ADDENDUM NO. 3

DATE: February 15, 2018
FROM: City of Grand Junction Purchasing Division
TO: All Offerors
RE: Las Colonias Business Park Phase I and Phase IA IFB-4476-18-DH

B TYPICAL 3-PHASE POWER PEDESTAL/LIGHTING CONTROL CENTER PLAN

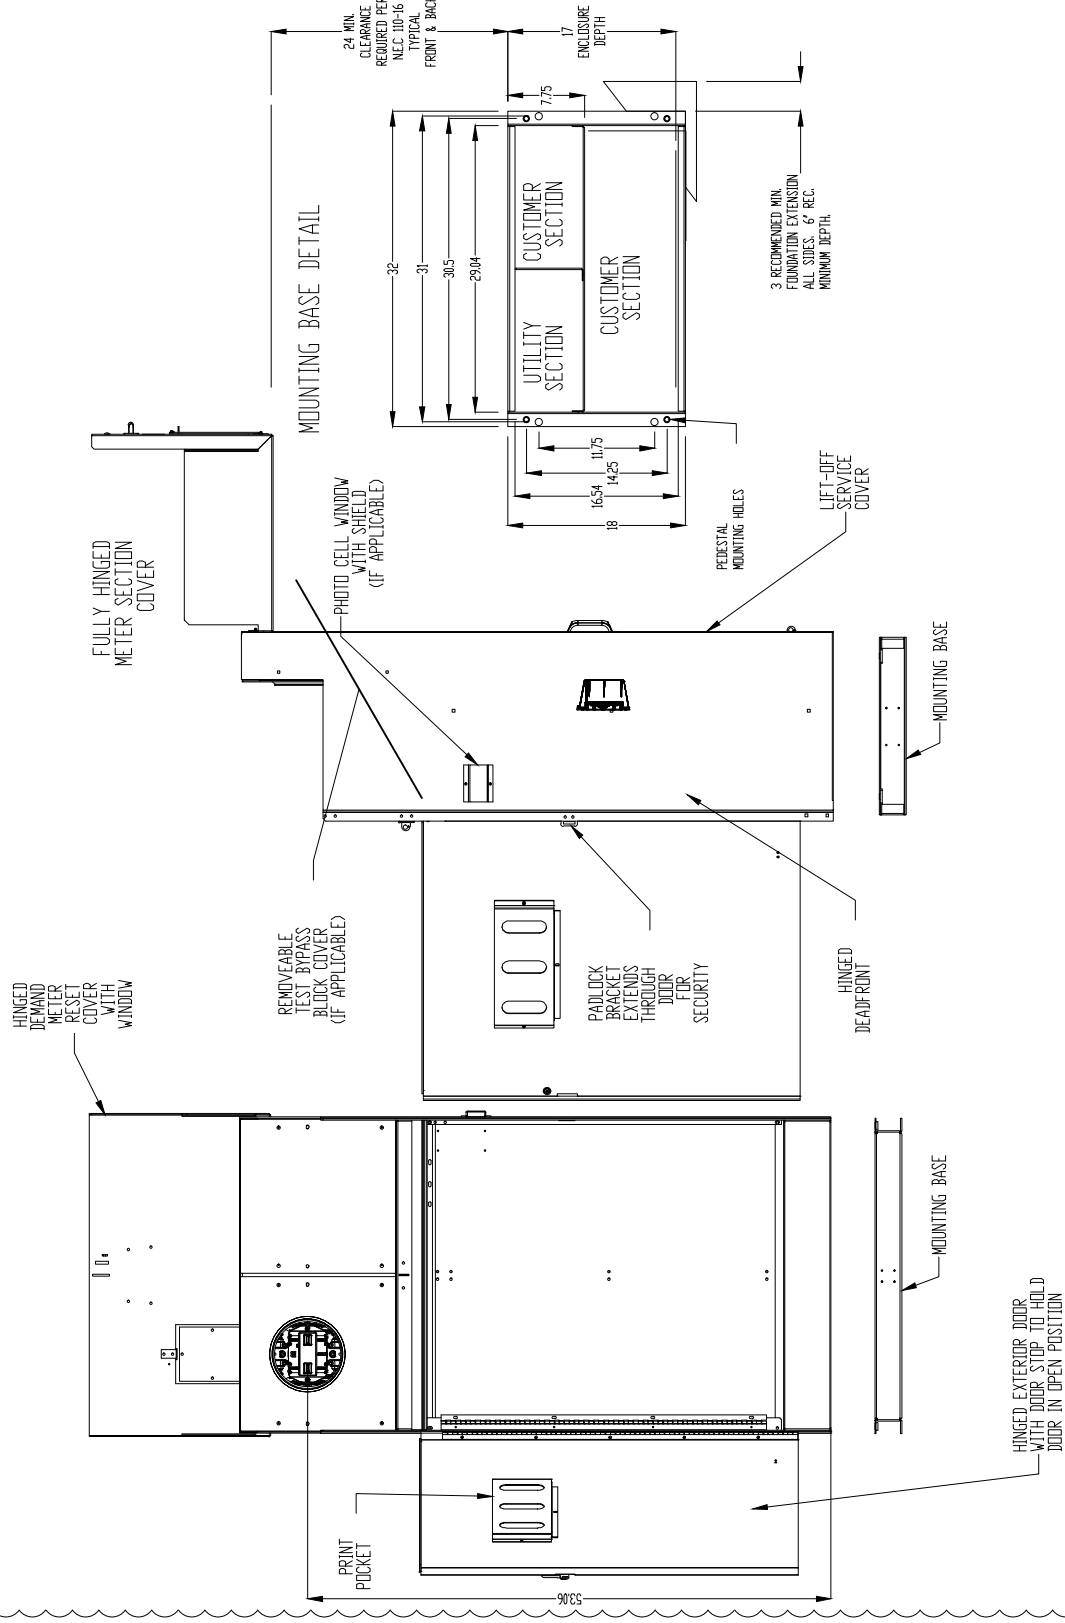
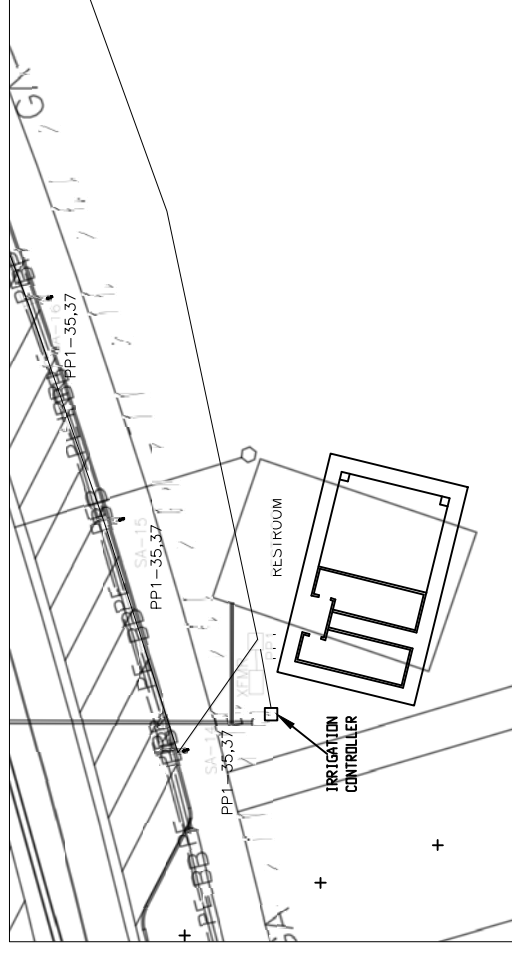
REVISION	DATE	DESCRIPTION
Δ	1/29/18	CLARIFIED JPH PANEL
Δ	2-12-18	
Δ	1/29/18	
Δ	1/29/18

TYPE SA LIGHT DETAIL

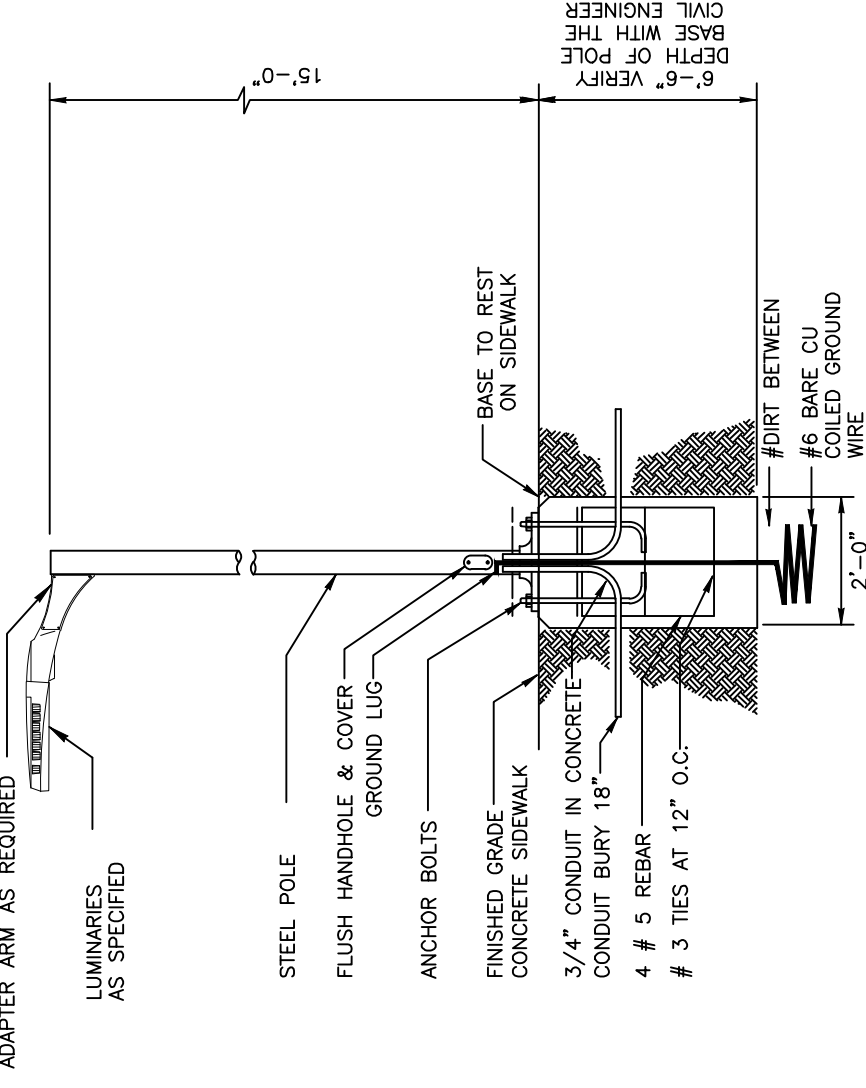
1. Q. Sheet E1 references MH Lighting and the catalog numbers shown are for Architectural Area Lighting. However, on sheet E11 the fixture schedule shows Philips Gardco whose rep is Visual Interest. Which is correct, or are both?
 - A. See revised plan set attached.
1. Revised Construction Plan Set(s) – See attached.
2. Revised Electrical Plan Sheets – See attached.
3. Revised Bid Schedule – See attached.
4. Existing Contour Maps – See attached.
5. Irrigation Pull/Valve Box Specification – Line Item Deleted. See revised plan set.
6. **Revisions to SP-8** - Revisions to subsection, **Payment will be made under:** shall be deleted and replaced with the follow:

TYPE	MANUFACTURER MODEL NUMBER	APPROVAL	VOLTAGE MOUNTING # OF LAMPS	LUMINAIRE SCHEDULE	
				BALLAST	DESCRIPTION
SA	PHILIPS GARDCO GL13-1-2-70L-A-6435-NW-208-BLP-LF	OWNER REQUESTED	208 POLE	ELECTRONIC LED	PEDESTRIAN LUMINAIRE, ARM MOUNTED, LED, CUTOFF, ORDER ROUND STEEL POLE SO THAT LAMP HEIGHT IS 15' AFG MEASURED AT BOTTOM OF LUMINAIRE. COLOR OF POLE AND ARM TO MATCH, BOTH BLACK. POLE # RS-15-4-D1-BLP
SB	PHILIPS GARDCO GL18-1-2-230L-A-9680-NW-208-BLP-LF P-C-RP-A2	OWNER REQUESTED	208 POLE	ELECTRONIC LED	STREET SIDE LUMINAIRE, ARM MOUNTED, LED, CUTOFF. ROUND STEEL POLE TO BE 27' SO THAT TOTAL HEIGHT AFG TO BOTTOM OF FIXTURE IS 27'. COLOR OF POLE AND ARM TO MATCH, BOTH BLACK. POLE # FRS-27-S-D1-BLP
